SERVICE BULLETIN

BULLETIN # 04-03
DATE: 9/5/2003
SUBJECT: 48 CONVERTIBLE
Fwd Headliner Accent Part – Reinforce Fastening Procedure
HULL #s: 09147, 31, 32, 33, 34, & 35

Step - 2

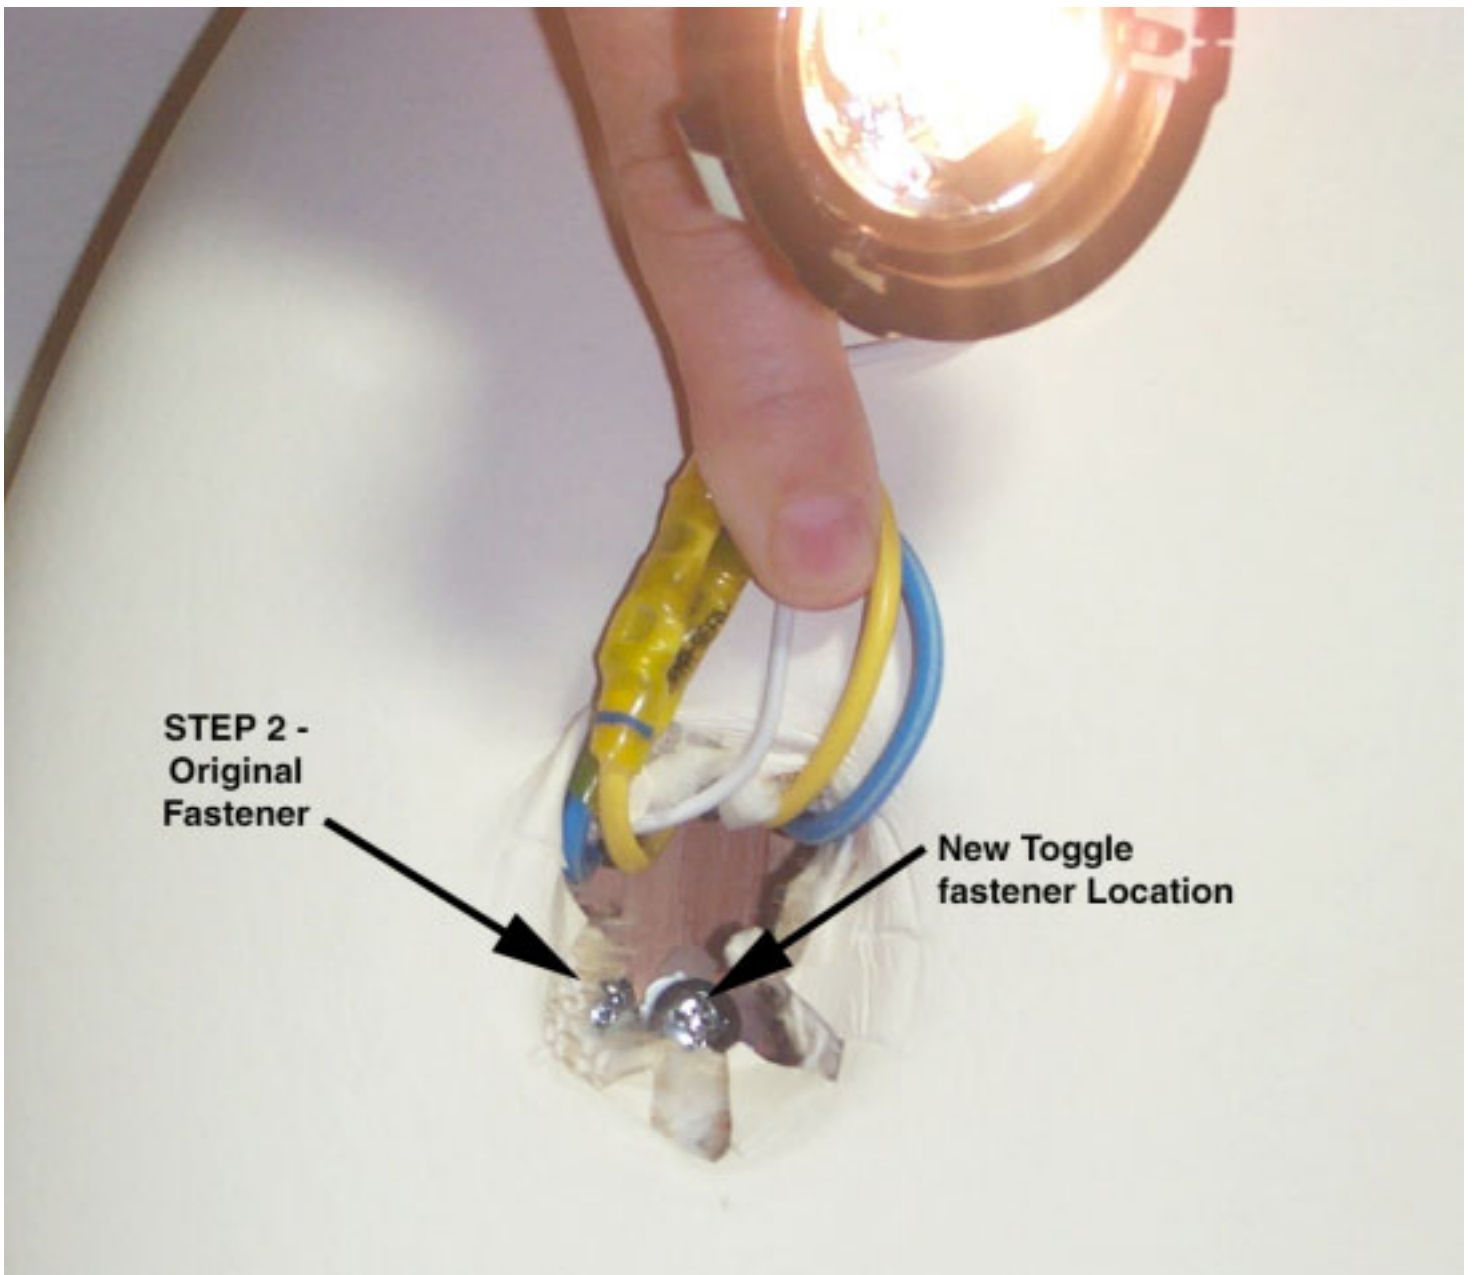
It has come to our attention that the headliner accent panel in the forward stateroom is not sufficiently secured. Over time, from the movement and vibration of boat operation it could come loose and fall.

1. Pull down the 3 cabin lights – you do not need to unhook them.
2. Drill a 1/2" hole through the plywood block above light hole and through headliner – each light hole area. *Note: Watch you don't drill wires for lights.*
3. Insert the toggle bolt through hole. Follow installation instructions
4. Use the 1/2" -20 x 1 1/2" pan head bolt to secure down tightly.
5. Reinstall cabin lights.

- Drill 1/2 " hole through
Both Parts
- Install Toggle Bolt-

- Install -20 X 1 PH Bolt
<Repeat this in the Last 2 lites>
